23/00288/FULL1 | Demolition of existing dwelling and garage and erection of a four storey building comprising 4No. one and 3No. three bedroom flats with underground parking for four vehicles and one external space. Refuse use store, cycle parking to frontage and associated site landscaping. | 8 Madeira Avenue Bromley BR1 4AY

We **object** to this application.

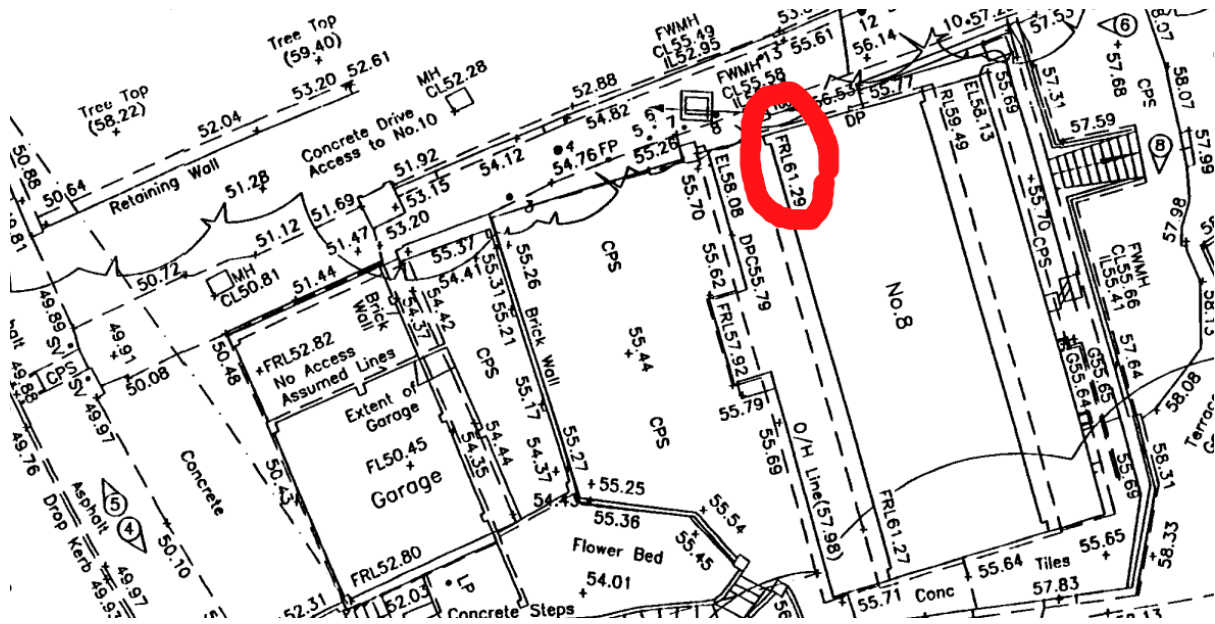
The datum point height of the proposal is 66.49m. Drawing number Y1148/2022/05 Rev 02 refers.

Thus, this new proposal, at 66.49m, is nearly 2.5m more than the existing permission and more than 5m taller than the existing building, according to the datum points provided by the applicant.

The proposal is clearly far too high if the stated datum points are accurate.

If they are not accurate, then correct data should be provided to enable a proper analysis.

1Above: 20/04942

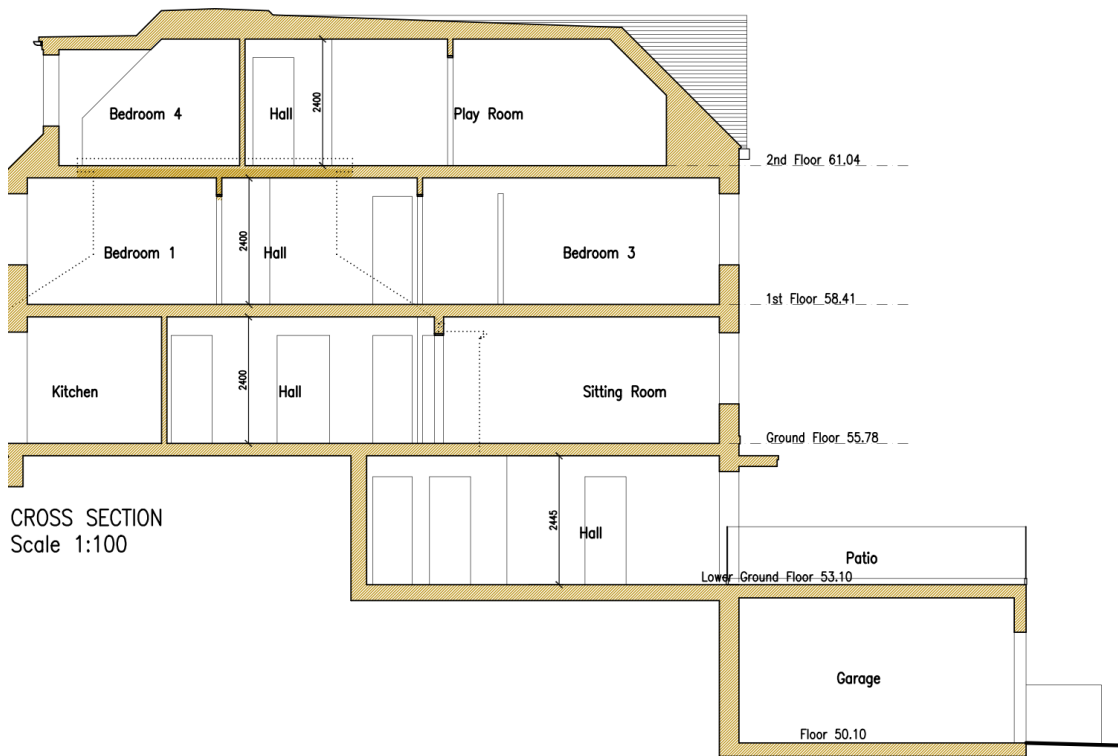
With regard to 20/04942 (allowed at Appeal) we calculated that the datum point at the top of that proposal was 64.04m as follows. Drawing 2684666 (below) shows the elevation heights for 20/04942 as being 61.04 to second floor level + 2.4 for room height + 0.6 for roof structure making 64.04m in total.

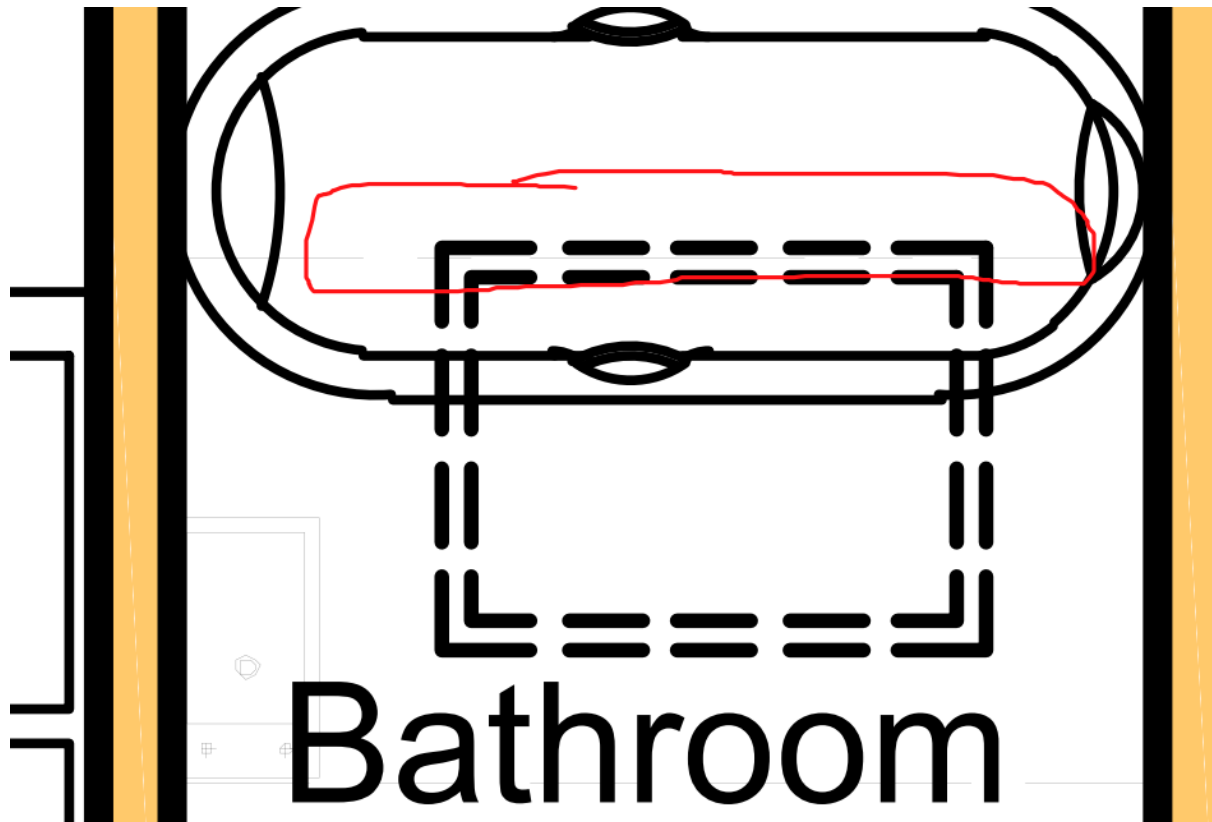
The standard of proposed accommodation on the top floor is concerning. The slope of the roof and the 1.5m height line significantly intrude on useable space. For example, the bath in flat 7 is all but unusable – how would you actually get in it, if at all less than fully fit and healthy? We have ringed the faint 1.5m line below.

Other basins, toilets, bath and showers are similarly constrained.

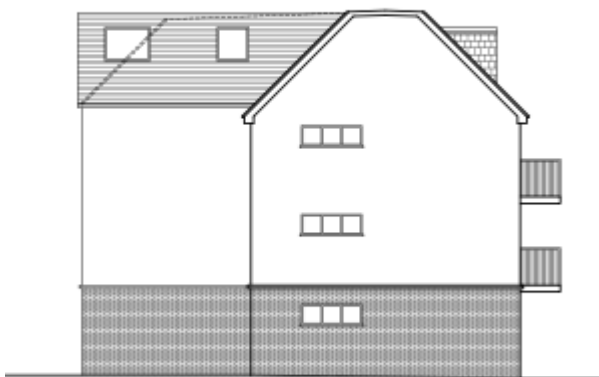
The roof plan shows that at the front right corner, the building would be closer than 1m to the boundary. This contravenes Policy 8 of the Bromley LP:-

- a) for a proposal of two or more storeys in height, a minimum 1 metre space from the side boundary of the site should be retained for the full height and length of the building;”
